**RE: Comments on Preliminary Flood Insurance Rate Map and Flood Insurance Study for the City of Ukiah Including the Areas Near Orrs, Gibson, and Doolin Creeks**

<b>To</b>	City of Ukiah		
<b>Copy to</b>	GHD Files		
<b>From</b>	GHD and the City of Ukiah	<b>Tel</b>	+1 415 283 4970
<b>Subject</b>	City of Ukiah FEMA Map Revision Review	<b>Project no.</b>	12589077

This memorandum summarizes GHD's and the City of Ukiah's preliminary review of the Mendocino County Map Revision (Orrs, Gibson, Doolin, and Zone AE) Updates, prepared by FEMA Region 9 and presented to the City of Ukiah (the City) in July 2024. This review included the preliminary Flood Insurance Study (FIS) and Flood Insurance Rate Map (FIRM) dated July 10, 2024, and the hydraulic analysis model and data provided by the FEMA's STARR II contractor team on September 11, 2024.

RE: Proposed changes to the FEMA Flood Insurance Rate Maps in and around the City of Ukiah, CA

Figure 2 Preliminary FIRM Panel 06045C1514G (July 10, 2024)

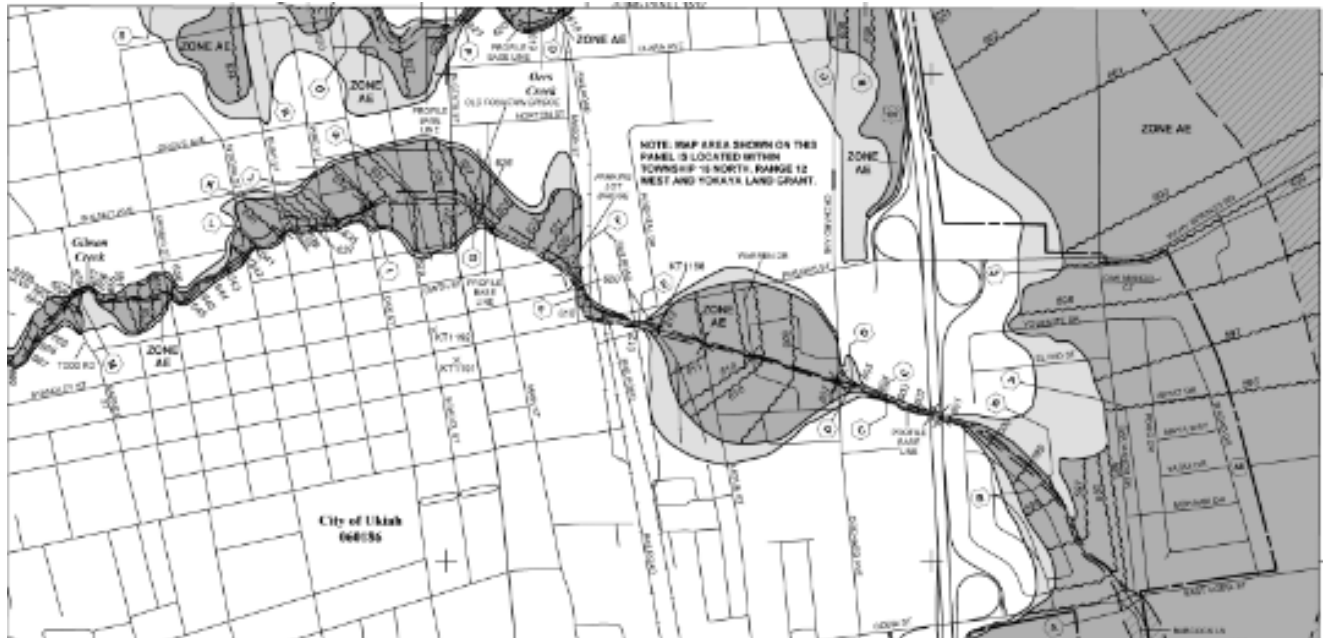
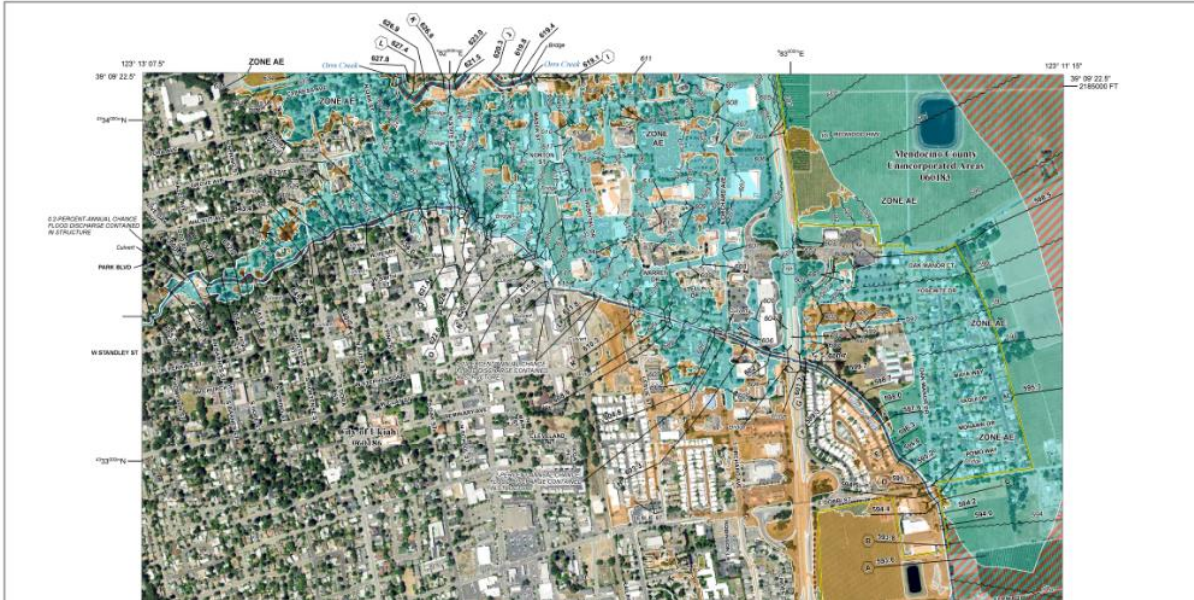
The preliminary FIRM shows proposed changes in the floodplain extent in the City. The preliminary FIRM generally shows additional floodplain areas, especially for Zone A and Zone AE. For example, in FIRM panel 06045C1514, a significant portion of the urban area between Orrs Creek and Gibson Creek is remapped as floodplain Zone AE, as shown in Figures 1 and 2. The changes are partly due to a different hydraulic analysis approach in this floodplain area. The hydraulic analysis for the effective FIRM was based on one-dimensional (1-D) creek modeling. The new hydraulic analysis for the preliminary FIRM included 1-D channel modeling with a two-dimensional (2-D) floodplain model to provide additional resolution to the floodplain flooding. These updates of floodplain extents in the preliminary FIRM may trigger new flood insurance requirements in the area.

The impetus for this review of the preliminary FIRM update concerned the large expansion of the SFHA along and between Orrs Creek and Gibson Creeks (Figures 1 and 2) within the City (Tim Eriksen, P.E., City of Ukiah City Engineer, personal communication). Based on comments and feedback from a long-time local engineer (Ron Franz) who has completed hundreds of Elevation Certificates in the City limits, flooding in these expanded SFHA areas has not occurred, even during the December 2005 flood event (Ron Franz, personal communication). For reference, the December 30, 2005 flood event on the Russian River near Ukiah (USGS station: 11461000) observed peak flow was 22,600 cfs and exceeded the 1% annual exceedance flow (100-yr event) of 22,100 cfs estimated by the USGS (Gotvald et al. 2012) for this station.

Figure 3 Army Corps of Engineers recorded High Water Marks for the December 1964 flood event—note lack of inundation within the majority of the City of Ukiah

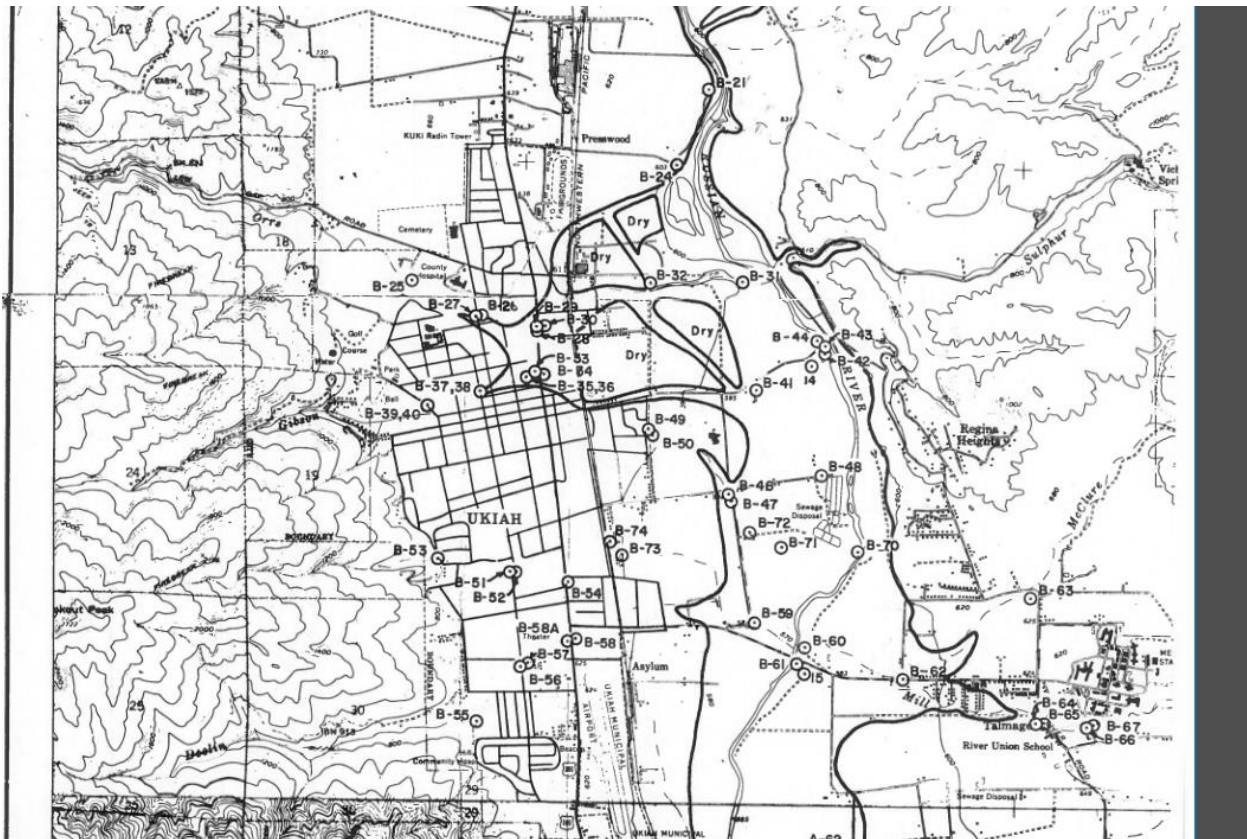
In addition, the largest known flood on record (December 1964), largely considered to exceed the 100-year flood depths, was surveyed by the Army Corps of engineers within the City limits. Figure 3 and Attached is the figure produced by the ACOE, which clearly shows the floodplain extents and the lack of inundation within the City limits. While we understand that channel conditions and hydrology can change over time, it is hard to believe that the current 100-year floodplain is so much larger and deeper in extent than that seen during the 1964 event.

Figure 4 North Spring Street Inundation (FEMA Preliminary 100-Year)

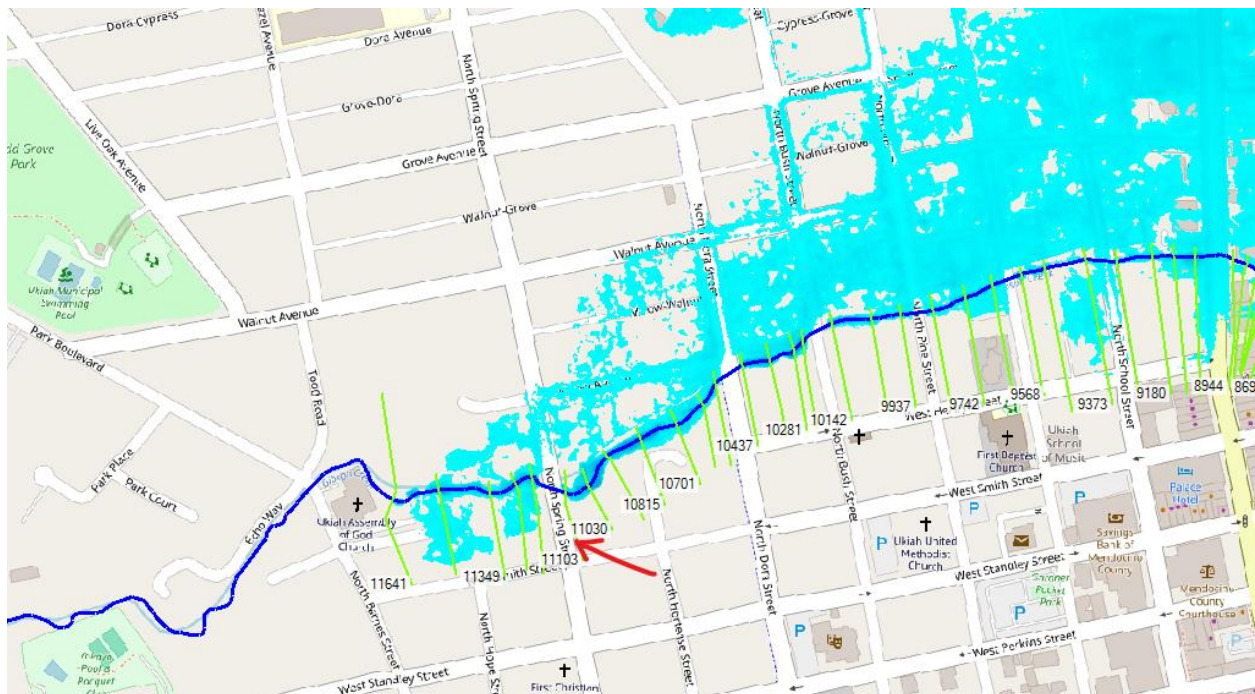
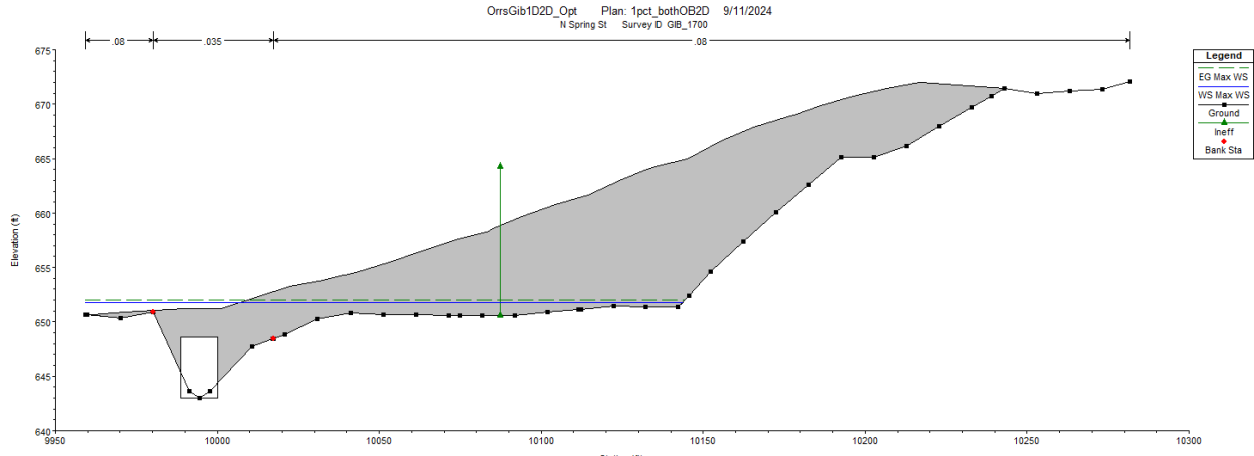
The North Spring Street crossing is the first structure on Gibson Creek in the HEC-RAS Model (Figure 4). During the 100-year storm event, the FEMA model predicts flow overtopping the crossing and contributing to floodplain inundation (Figure 5). The City Engineer, who grew up at 345 N. Spring Street near the creek and Spring Street intersection, reports no history of flooding in this area.

Figure 6 North Pine Street Inundation (FEMA Preliminary 100-Year)

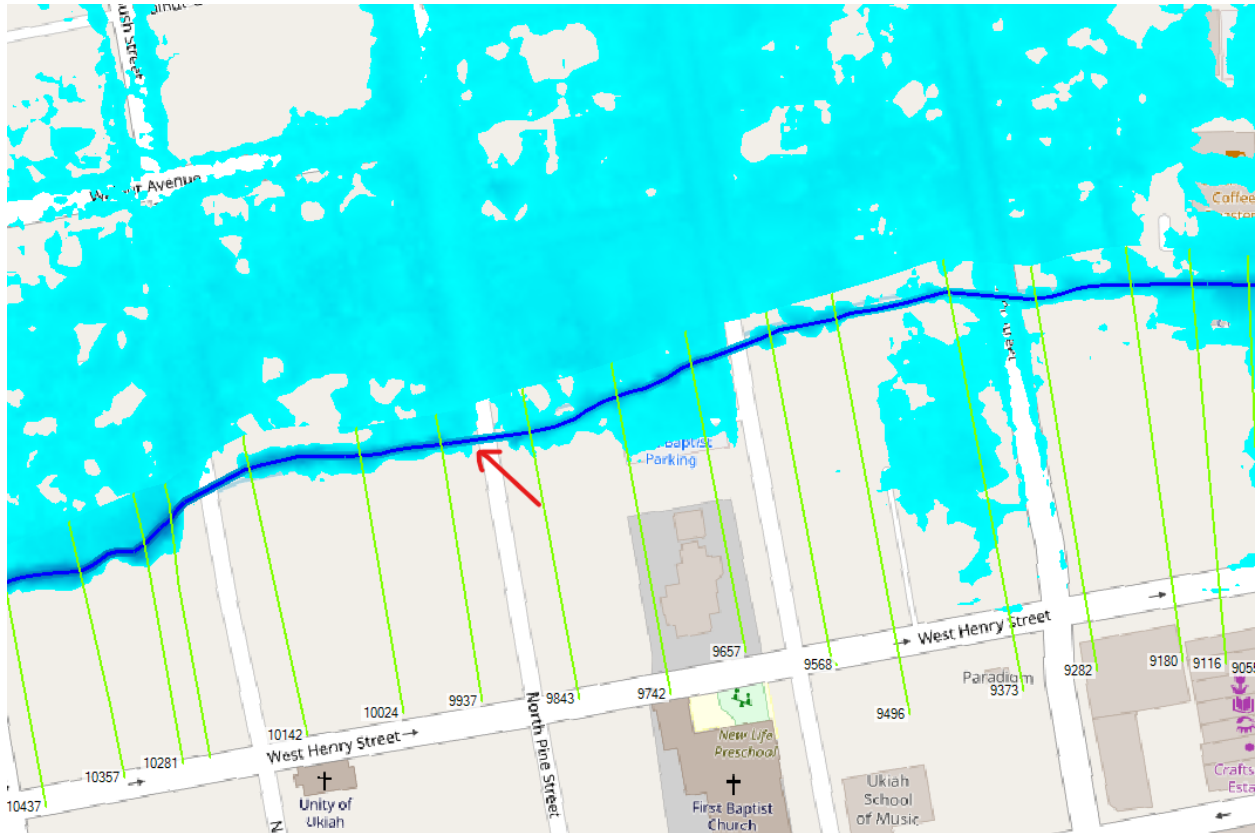
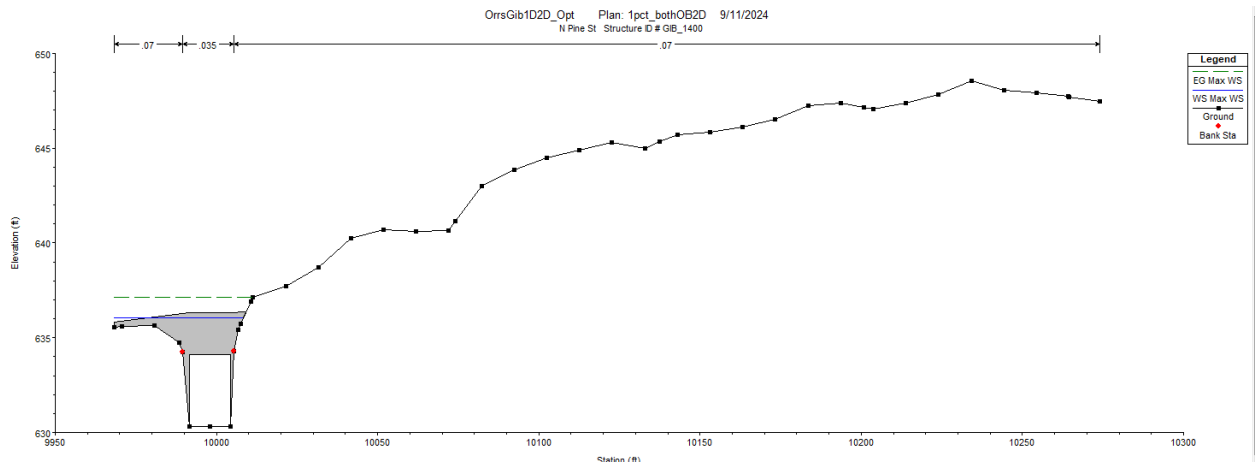
The FEMA Preliminary model predicts over 140 cfs leaves the Gibson Creek channel between the North Pine Street crossing and the North Oak Street crossing. Both of which City staff report no history of flowing issues in past. Assuming the structure geometries are entered correctly into the model, excessive peak flows may result in artificial flooding sources in these locations.

The City Engineer has never observed flooding in these locations. Additionally, the model's cross sections show the 10-year event as having higher water levels than the 100-year event, which is inaccurate. The 10-year event has never overtopped this area, raising concerns that the model's inputs may be incorrect.

Figure 9 Orchard Avenue Inundation (FEMA Preliminary 100-Year)

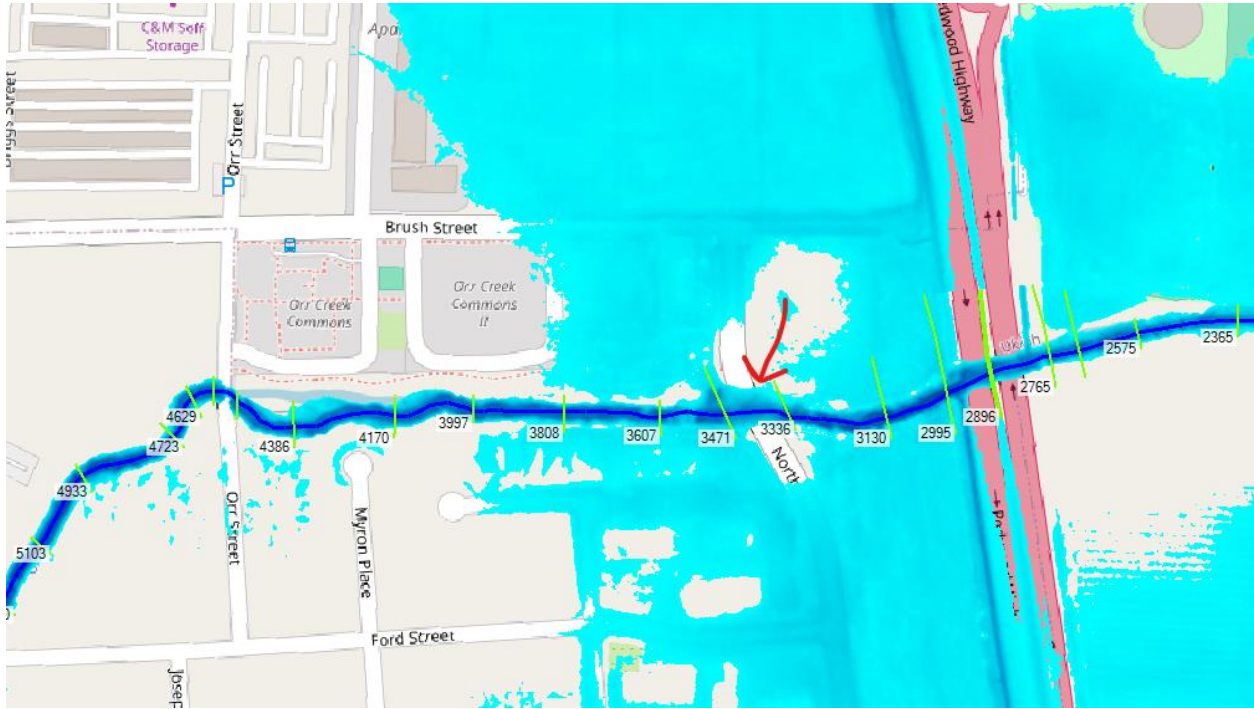
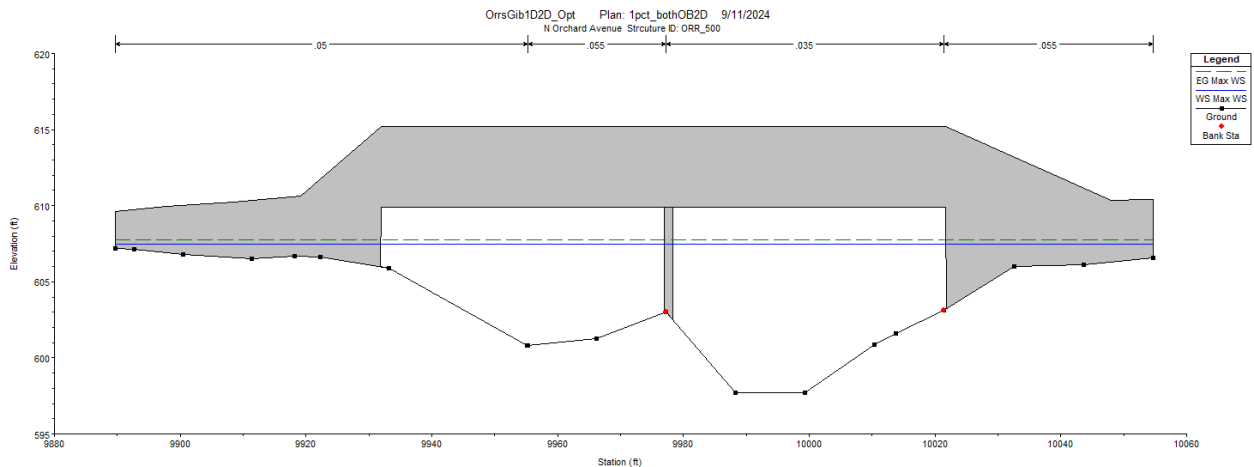
The Orchard Avenue Bridge was built in 2012 and was subsequently required to be built to modern building standards including building for the conveyance of the 100-year design storm event. The FEMA Preliminary Model predicts the backwatering of the Orrs Creek Channel upstream of the bridge resulting in over 500 cfs leaving the channel to the right and left floodplain areas. City staff report no known flooding instances at this location, indicating an unrealistic prediction of flooding in this area.

Figure 11 FEMA 10-Year Max. Inundation depth

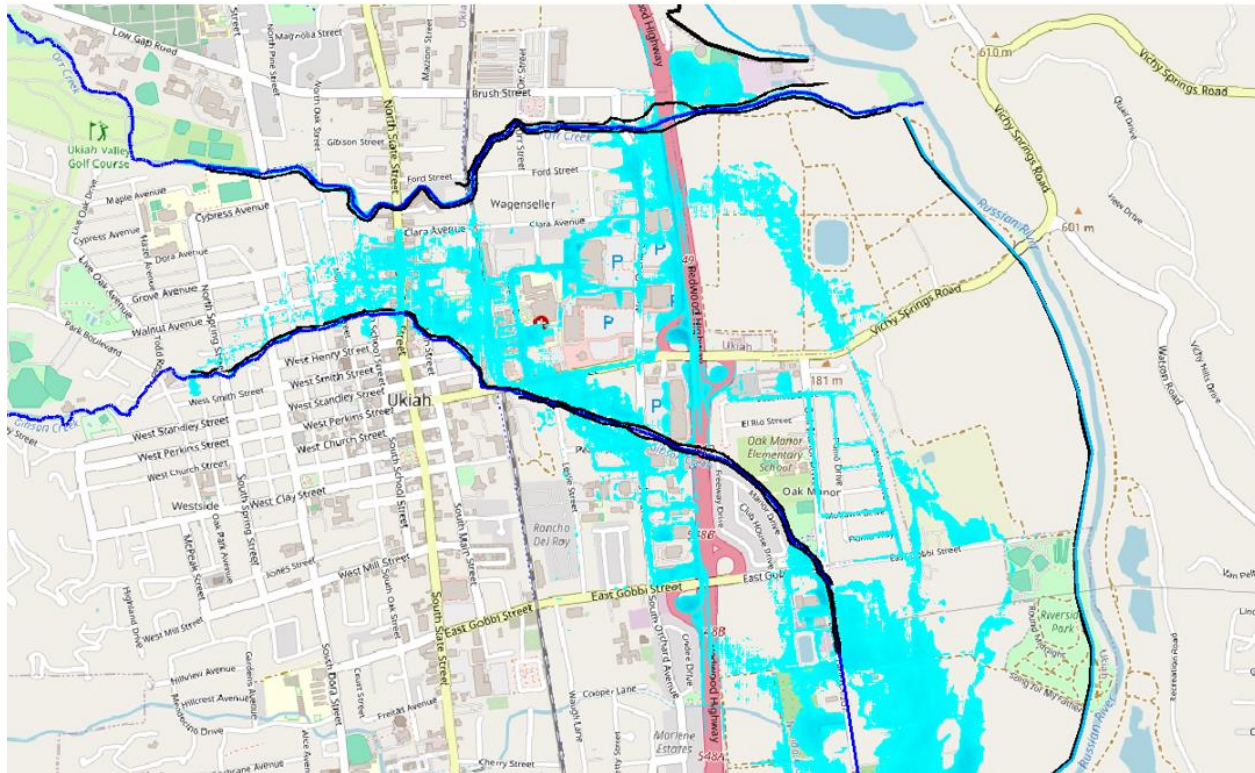
In addition to the number of the crossings within Orrs and Gibson Creeks which show overtopping during the 100-year event, the provided HEC-RAS model developed by the STARR team also includes floodplain inundation associated with the 10-year storm event (Figure 11). Over the past 10 years, the City of Ukiah has experienced a number of storms close to and exceeding the rainfall totals of a 10-year event. City Public Works and City Engineers both report no significant flooding inundation with the City. Compare that to the predicted 10-year inundation extents and it raises a number of questions to the validity of the results provided by the HEC-RAS model. In some places the model is predicting over a foot of depth during the 10-year event. For example, the Orchard Avenue Bridge previously discussed and installed in 2012 shows significant channel overtopping during the 10-year event. A bridge crossing that City staff have never seen reach anywhere close to the top of bank, let alone overtop and contribute to floodplain inundation.

**Figure 12** FEMA 10-Year Max. Inundation depth in Peach Street Subdivision

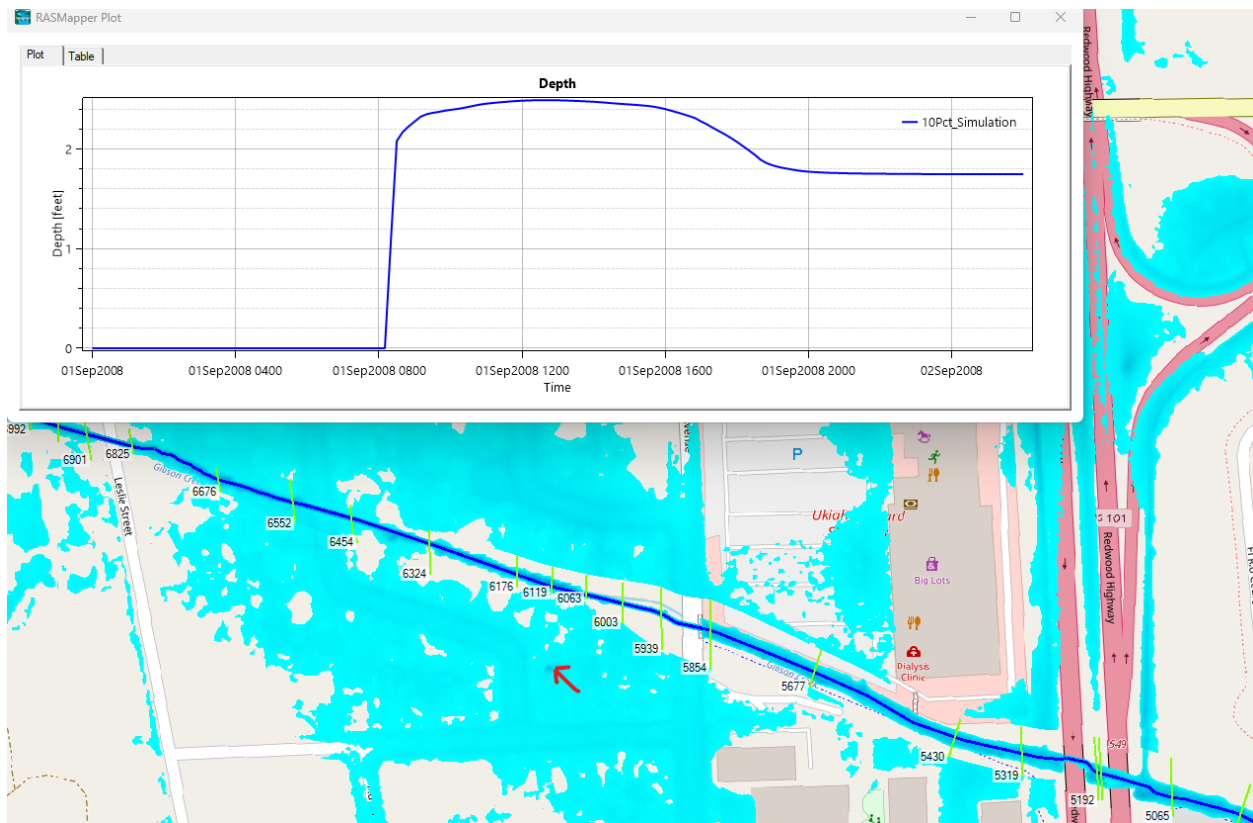
The model shows that the neighborhood bordered by Peach Street, Orchard Avenue, Leslie Street, and Perkins Street would be completely inundated in a 10-year event. The city engineer has never seen any flood activity in a 100-year or 10-year event. To make it worse, the model shows that in a 10-year event the water depth would be 2.5 feet (Figure 12).
